REVIEW OF THE VOGTLE UNITS 1 AND 2 AUXILIARY  
FEEDWATER SYSTEM RELIABILITY ANALYSIS

A. Fresco, R. Youngblood and I. A. Papazoglou

Department of Nuclear Energy  
Brookhaven National Laboratory  
Upton, NY 11973

October 1984

BNL Figure 6

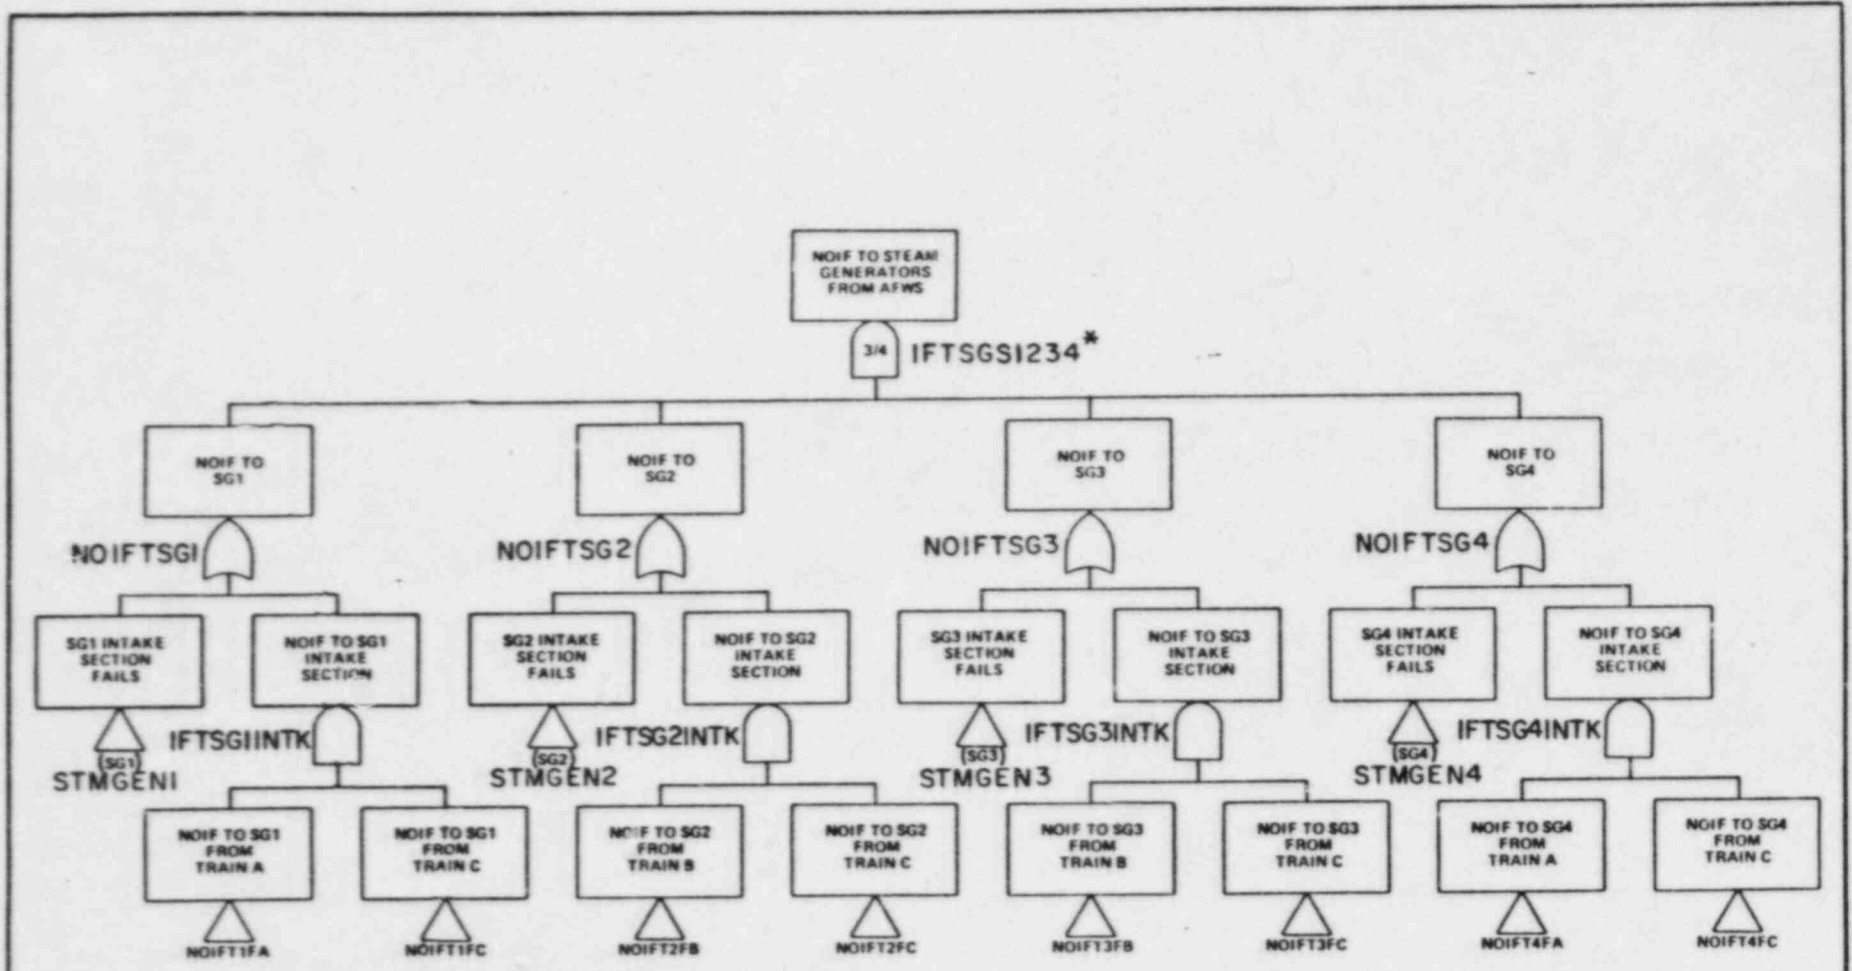
The fault trees as shown allow unrestricted coincident test and maintenance acts. Those acts which are not allowed by the Technical Specifications were then deleted from the cutsets by use of the DELETE TERM option of the SETS code. Specifically, the equation establishing the terms to be deleted is based on the Expanded Reliability Block Diagram in Figure 6, and is given below:

$$\text{DELETE} = A*B + B*C + A*C$$

BNL Figure 7 (Sheet 11 of 33)  
UNIT 1 APWS FAULT TREE MODEL  
FSAR

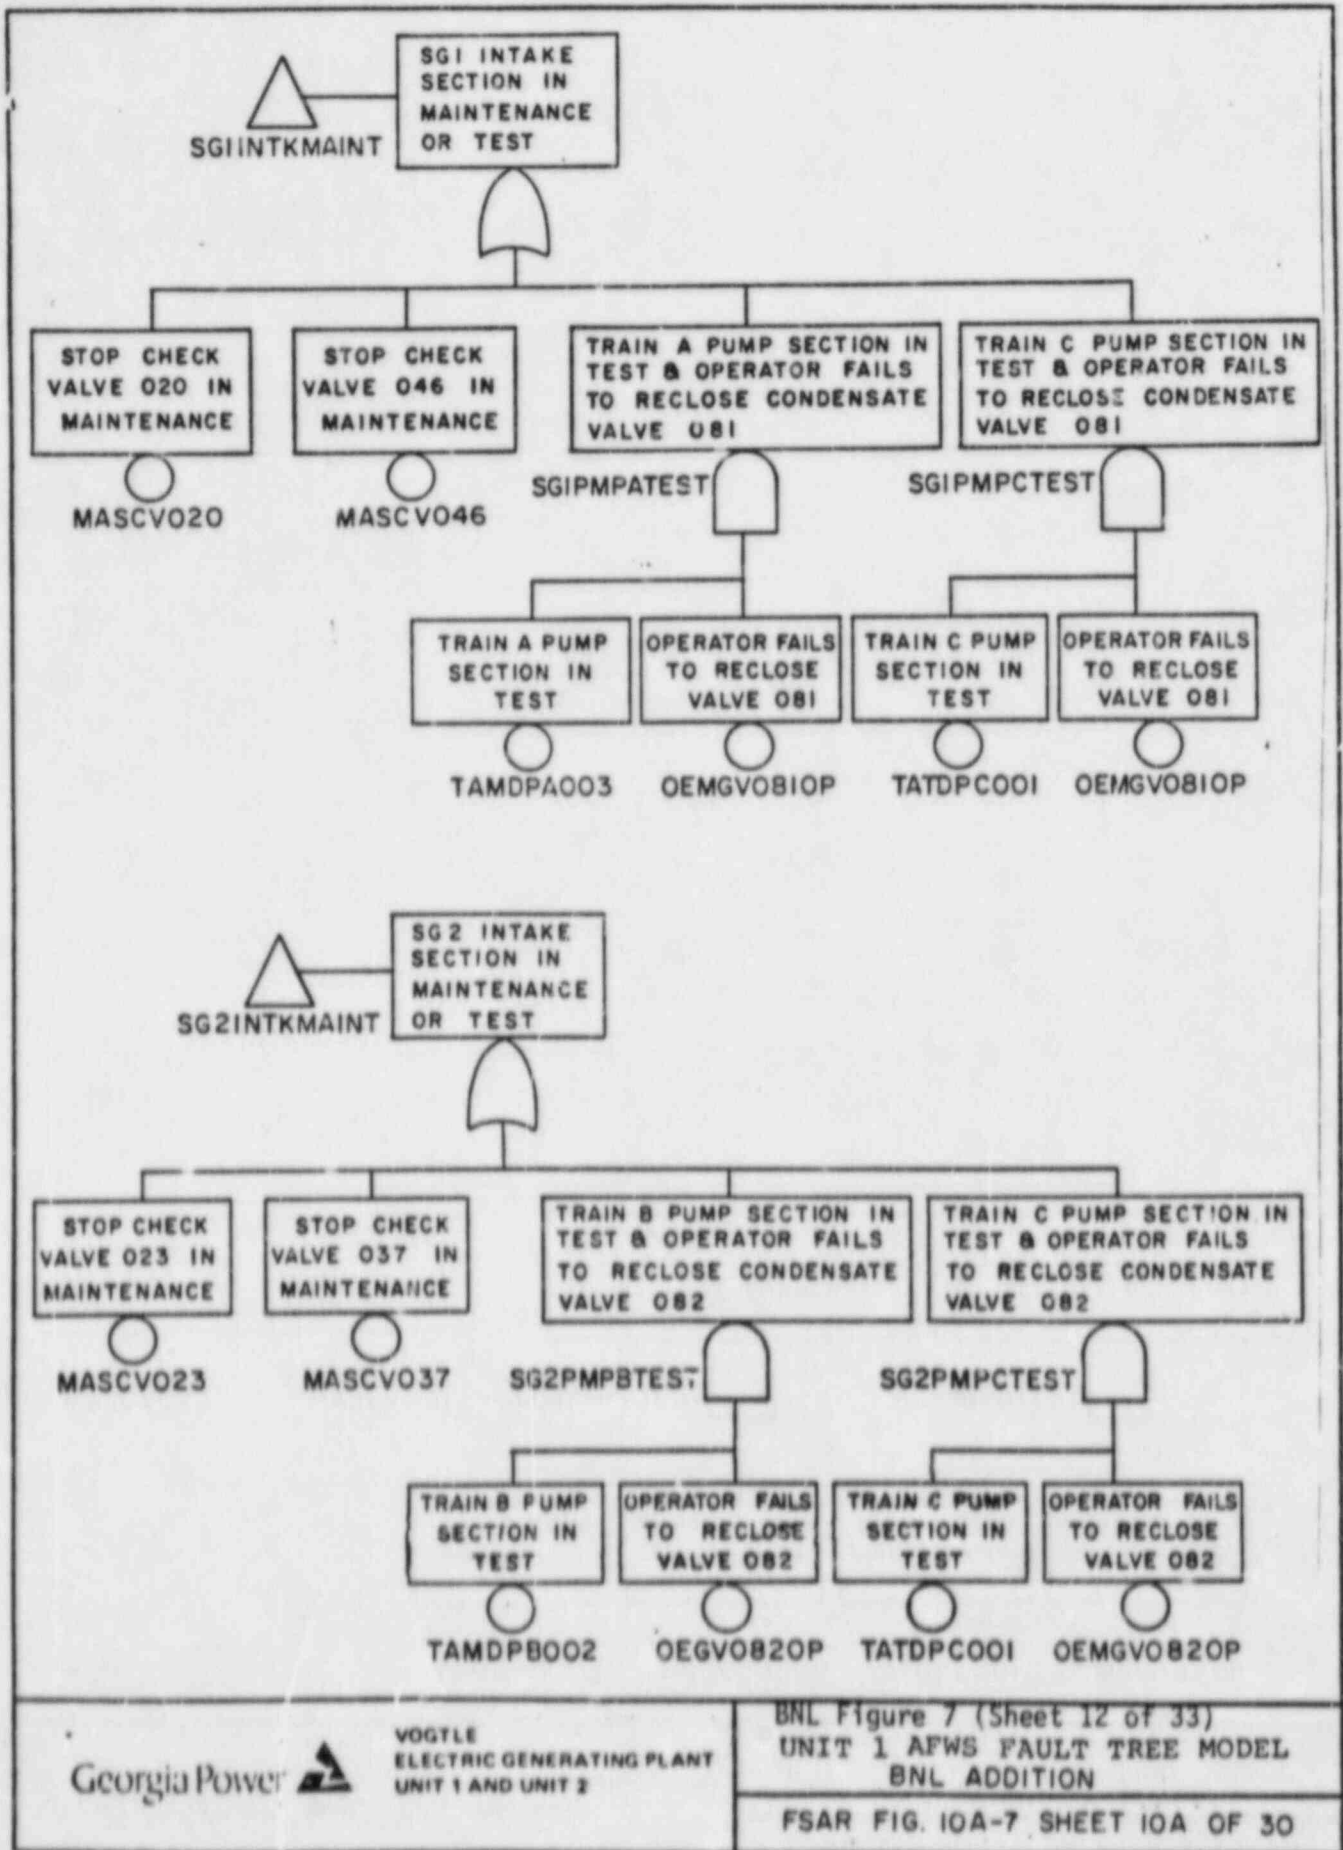
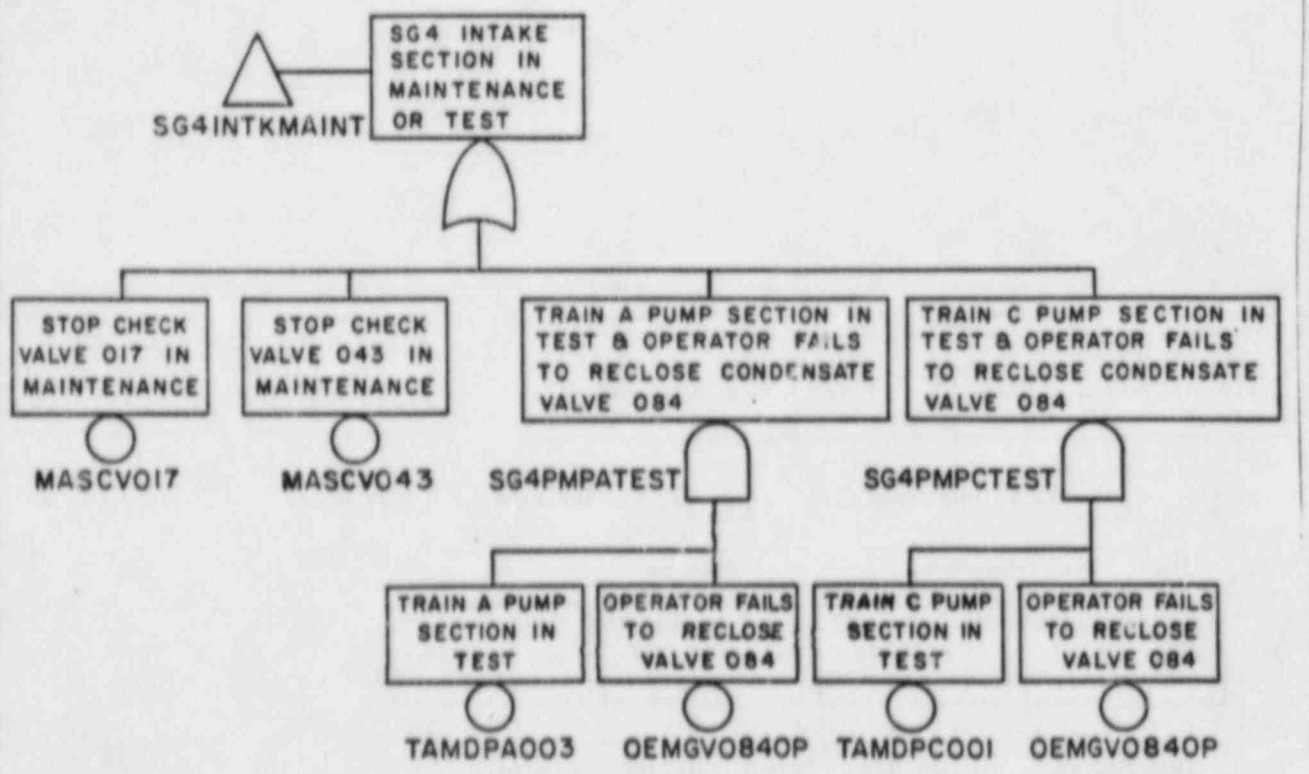
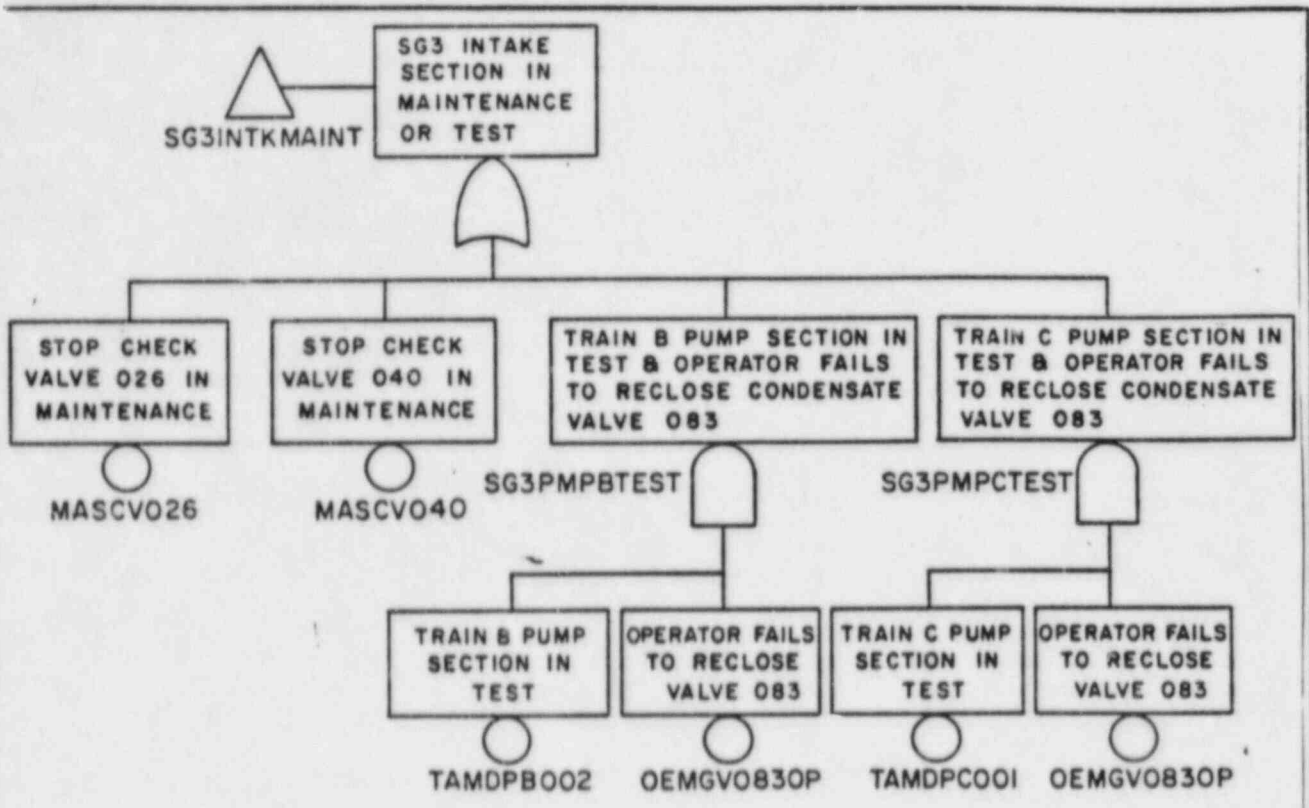
Since the applicant's fault trees, provided in Ref.3, seem to be substantially correct and complete, particularly with respect to the modeling of maintenance acts at the component level, these same fault trees with minor revisions were utilized in the BNL analysis, provided in this report as Figure 7, Sheets 1 to 33. The major revisions which were necessary were the addition of fault identifiers and a finer separation of certain maintenance acts so the top event could be properly identified and the non-functional event "Does Not Violate Technical Specifications" eliminated. The fault identification nomenclature scheme is shown in Table 6. The applicant did not separate the steam generator intake sections in the expanded block diagram, Figure 6, into random and maintenance contributors because no maintenance can be performed on either of the two check valves or the stop check valve in a typical intake section, e.g., check valves 121 and 125 and stop check valve 113 on Steam Generator 1 Intake. However, BNL did so in order to model both maintenance on

the stop check valves on the pump discharge lines to a given steam generator and also a possible unavailability due to testing if the operator fails to reclose the recirculation valve in the condensate system return line. See Figure 7, Sheets 12 and 13.

BNL Figure 7 (Sheet 14 of 33)

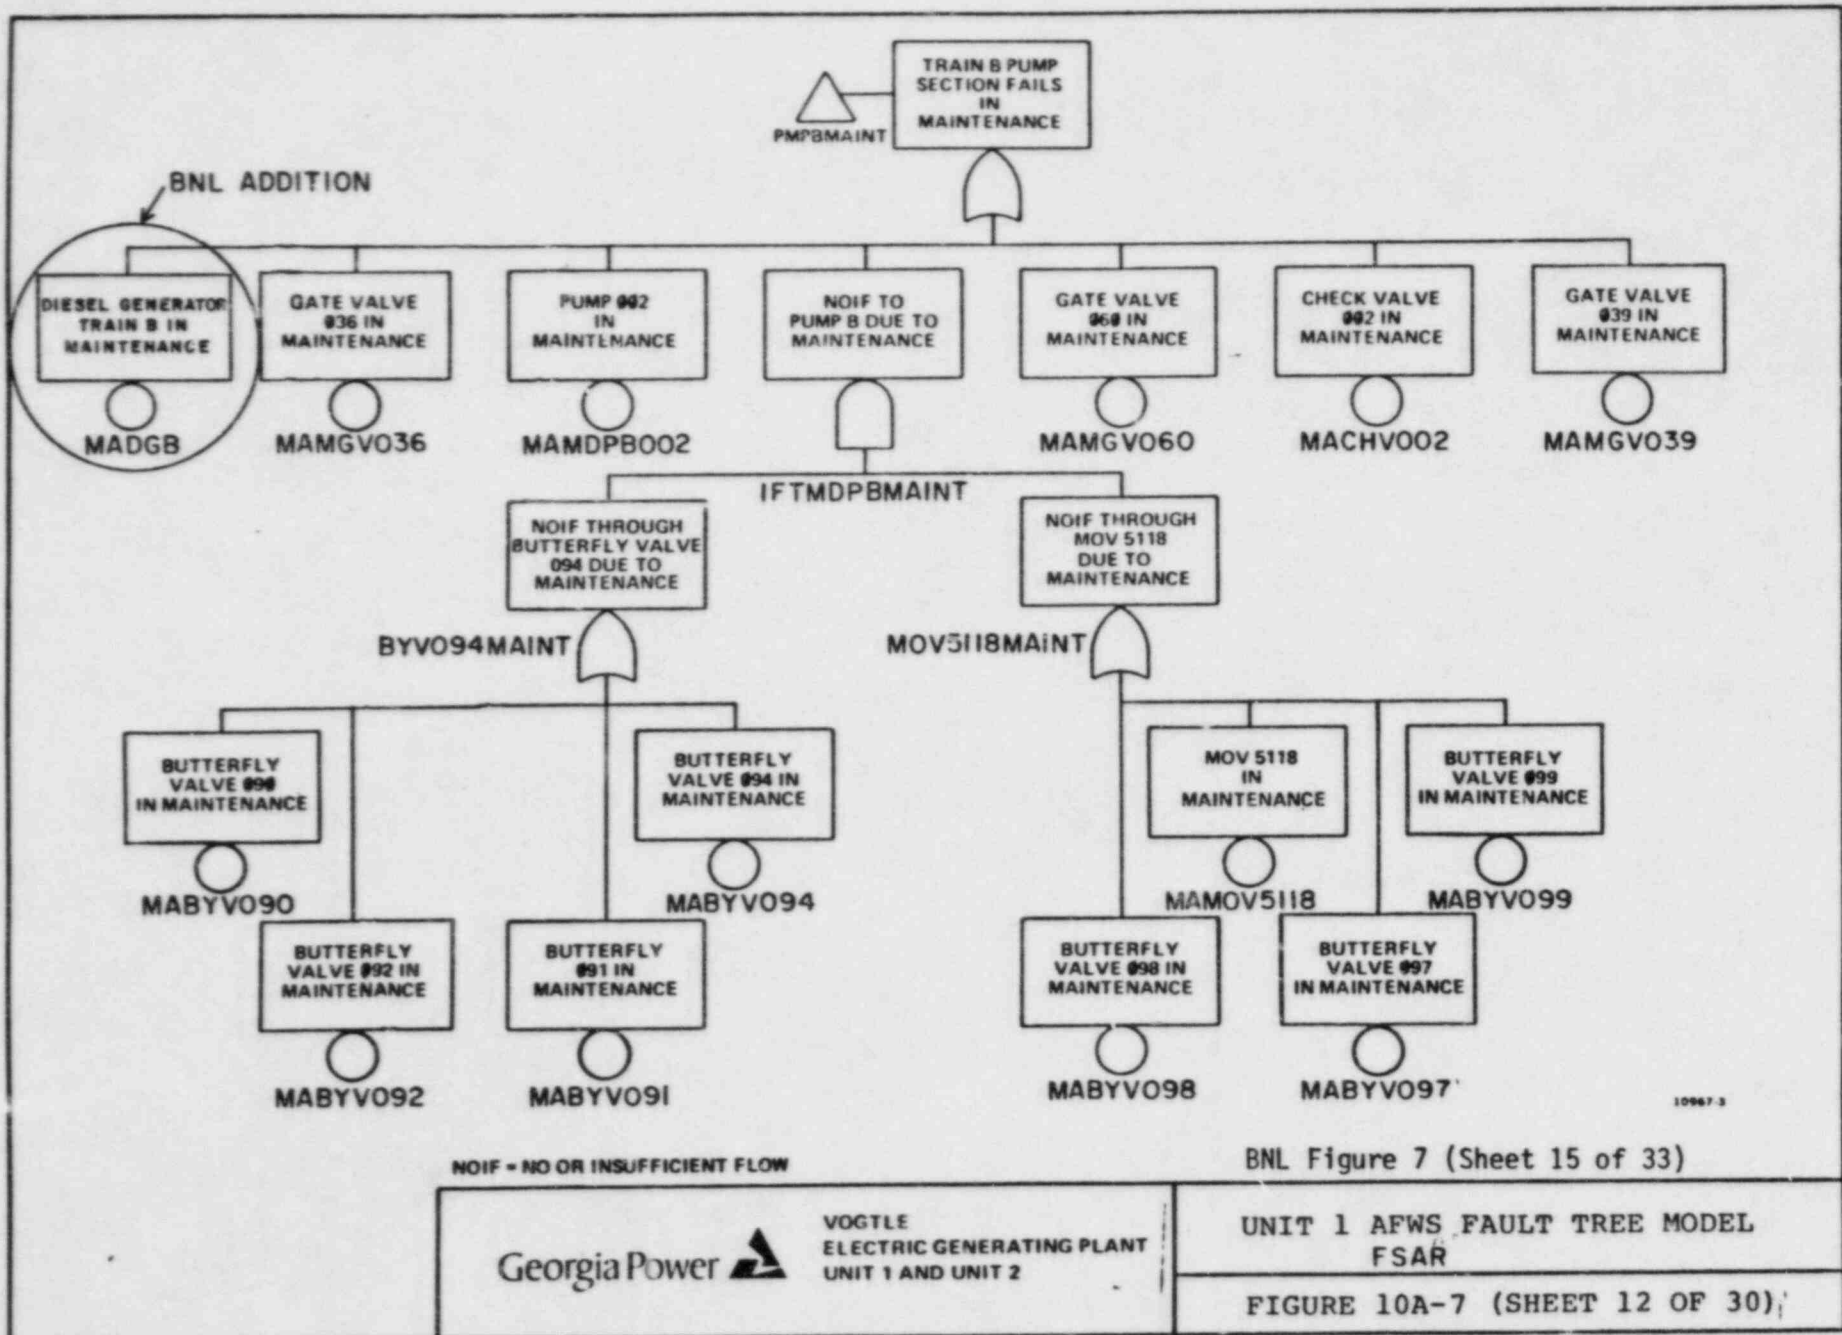
Another significant revision was the inclusion of diesel generator maintenance unavailability on Sheets 14 and 15. There were other minor revisions which are identified on the fault trees. It should also be noted that the top event on Sheet 1 was modified to show the actual gate names and the Boolean expression which was used to replicate the 3 out of 4 combination gate used by the applicant in the WAM-CUT code. The SETS code used by BNL does not utilize combination gates.
